**PLANNING COMMISSION MEETING
MUNICIPAL CENTER COUNCIL CHAMBERS
Tuesday, June 5, 2018**

5. Revised Final Site Plan Approval for a Parking Lot Expansion

Development Case Number	(15-560)
Case Name:	Harvest Church Parking Expansion
Location:	3645 Forest Hill-Irene Road
Owner Name/Applicant Name:	Harvest Church of Memphis - William Garner (Lead Pastor)
Representative Name:	Fisher Arnold – Michael Rogers (Agent)

5. The Grove at Germantown Performing Arts Center (GPAC)– Request Revised Preliminary and Final Site Plan Approval

PROPOSED REVISED SITE PLAN (ENLARGED COPY OF PLANS ARE INCLUDED WITH THIS REPORT)

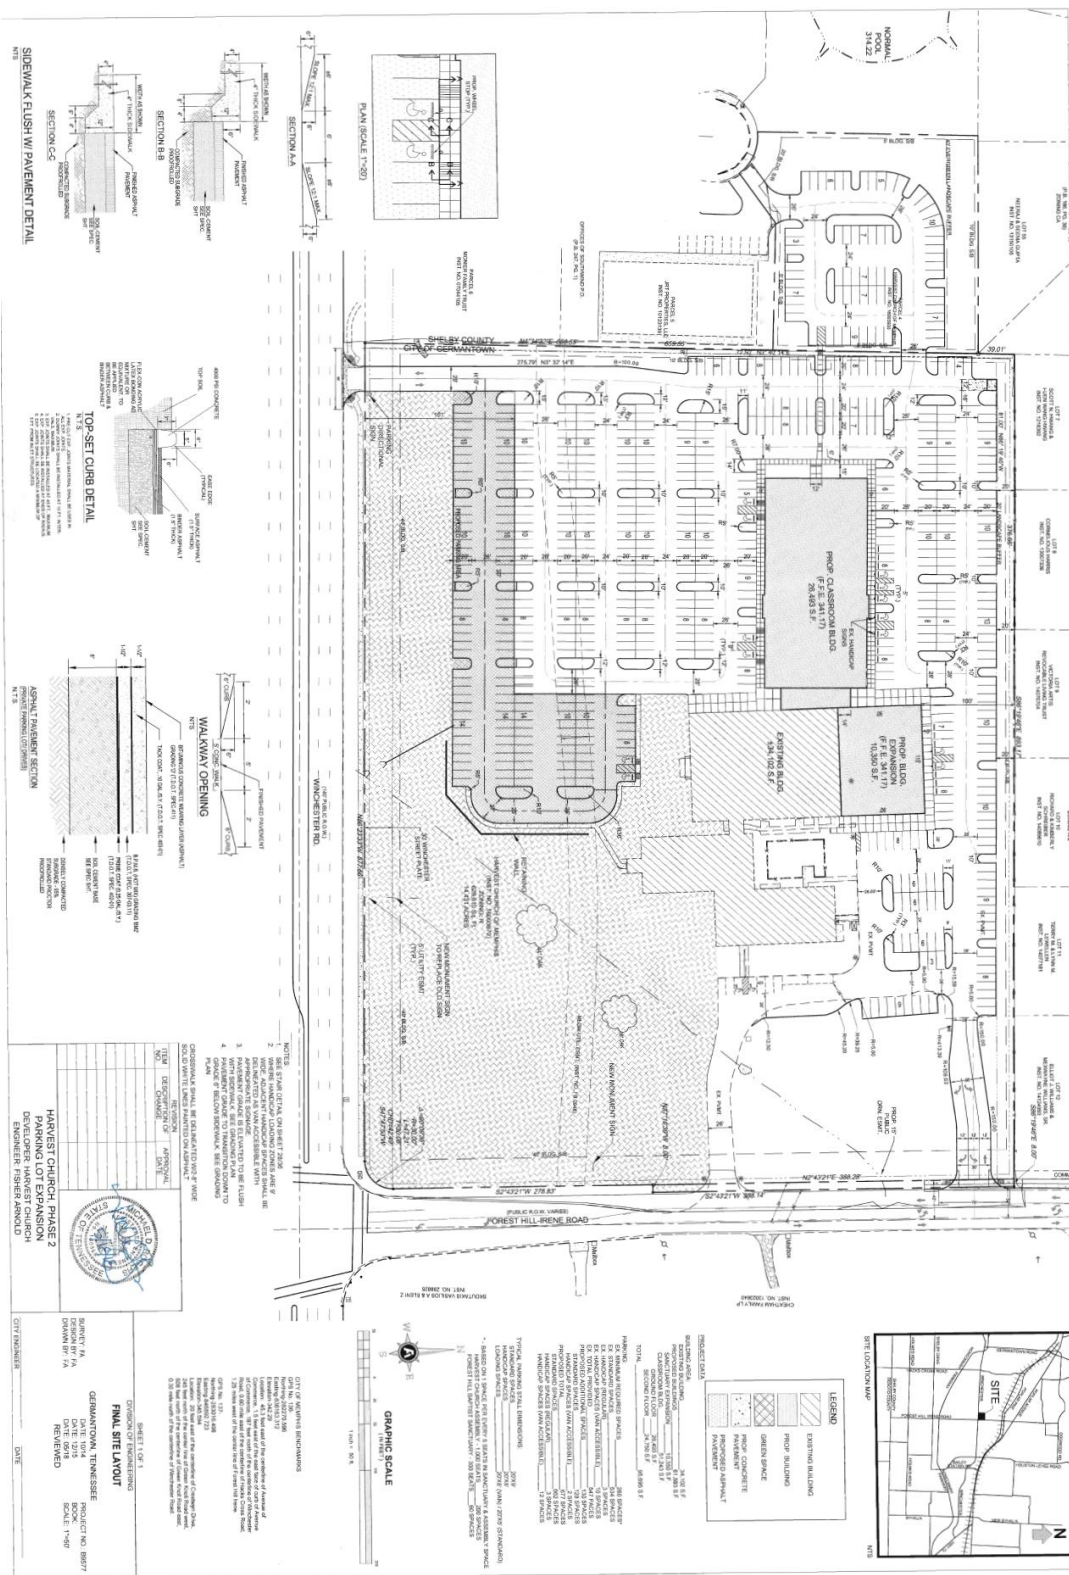
1. The applicant shall revise the information table on the proposed, revised site plan to show the correct parking calculation.
2. Following Planning Commission, this application shall be reviewed and approved by the Design Review Commission.

3. With the Design Review Commission submittal, the applicant shall provide a detail of fencing/safety feature along headwall.
4. Following Planning Commission and Design Review Commission approvals, the plat shall be revised and re-recorded to show the revised locations of the landscape buffer.

1. Sidewalk extension. The sidewalk shall be extended along Winchester Rd., to match property to the west.
2. Should a parking lot expansion be approved, this would require new fees and a new development contract.
3. Provide fencing/safety feature along headwall.
4. Obtain all City of Memphis/Shelby County approvals for drainage and drive connections.

1. Please provide documentation that MLG&W has reviewed the additional parking area that is over their existing easement and is in agreement, as well as the proposed water main and a fire hydrant that is to be located within the easement.

2. Please explain how the proposed development addresses water quality.
3. Please provide further explanation of how the 30" RCP pipe will be able to accommodate the additional flow discharge from the proposed development.

PROPOSED REVISED FINAL PLAN

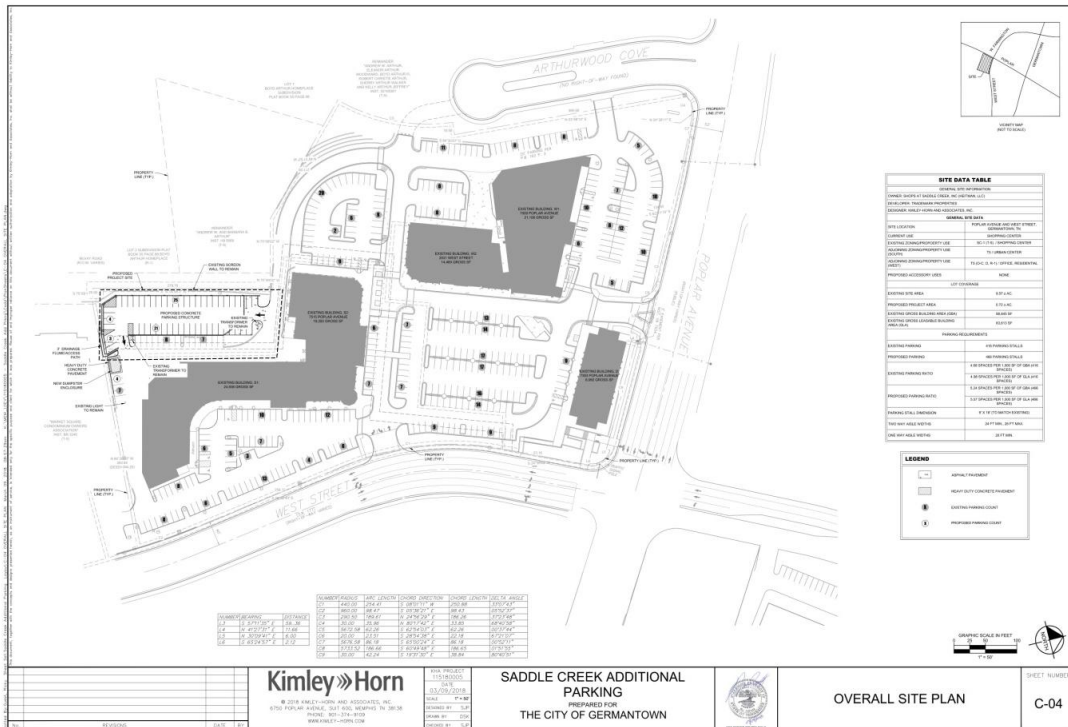
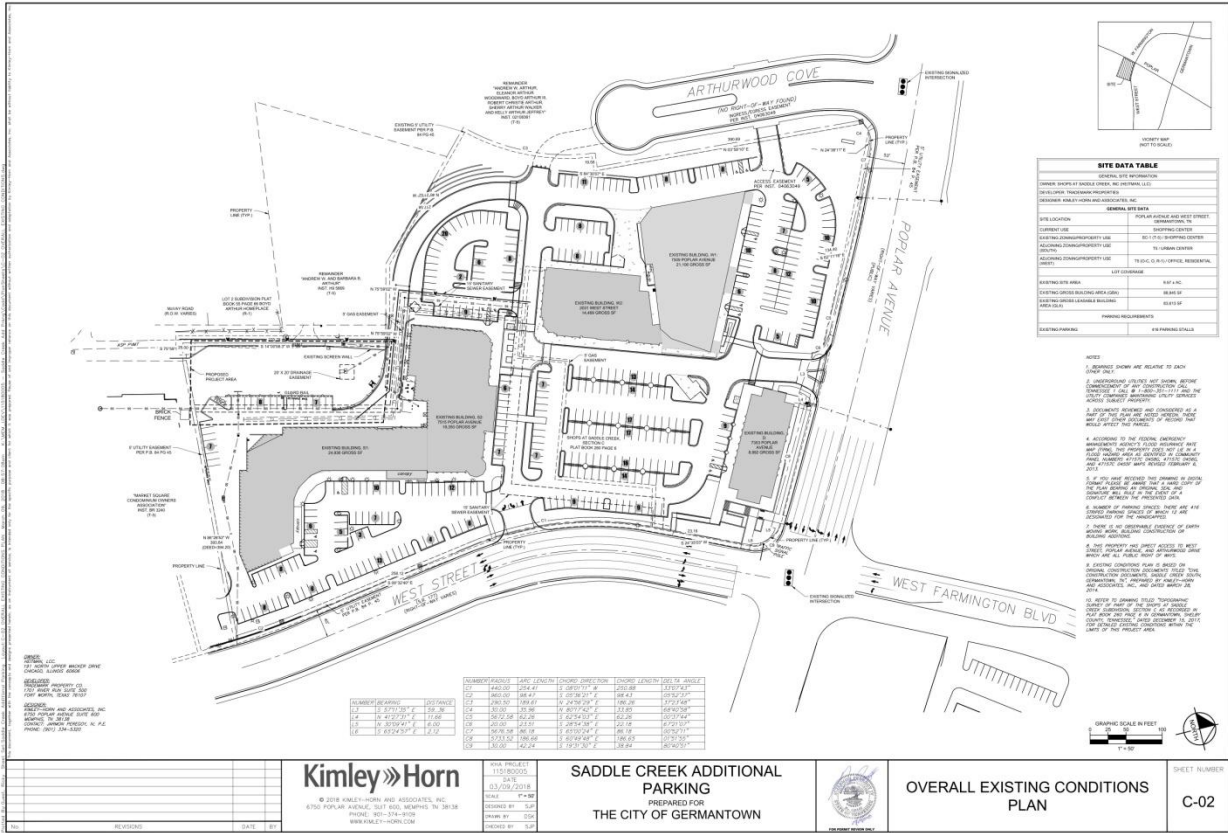
5. Revise site plan to show entire site including the complete parking area with parking counts, new and existing trash collection areas, loading area, etc.
6. Provide additional information on the food truck staging area, including an exit strategy. Consider a turnaround at the end of the drive aisle. Are power outlets provided, so that generators do not have to run (especially during performances)?
7. Provide bicycle parking and show location on plan (required Sec. 23-792(f))
8. Provide color elevations with notes about materials

1. Show additional trees that need to be removed due to conflicts with utilities as indicated on plans.
2. Add "Structure" table to Grading and Drainage plan next to "Pipe" table.
3. On sheets other than the tree removal sheet, don't show the trees that are to be removed.
4. More separation is needed for the water and electric lines serving the food trucks.
5. Cannot save the 26" oak that has the water and electric lines running through it serving the food trucks.

9. Utilities: Please provide complete utility relocation plan.
 - a. Show which PVC pipes are to be removed
10. Electrical & generator: Does the proposed electrical system tie into an existing generator? If so, is sufficient capacity there? If not, propose an alternate solution for emergency lighting, etc.

11. Stormwater and drainage
 - a. Provide more information on the location of drainage line under the pavers in front of the stage, its depth, how will it be maintained, etc.

1. Needed: Greater detail on drainage, water, and sanitary sewer plans.
2. Main issue: Utility pipe under proposed stage location. The solution has been provided to route around the permanent stage. Per PW, solution much better than the original proposal.

3. Concern: Sewer lines. Provide sewer plans and confirmation from Shelby County Code that proposed installation is permitted.
 - a. Indicated as tying into the building sewer, which is not common practice.
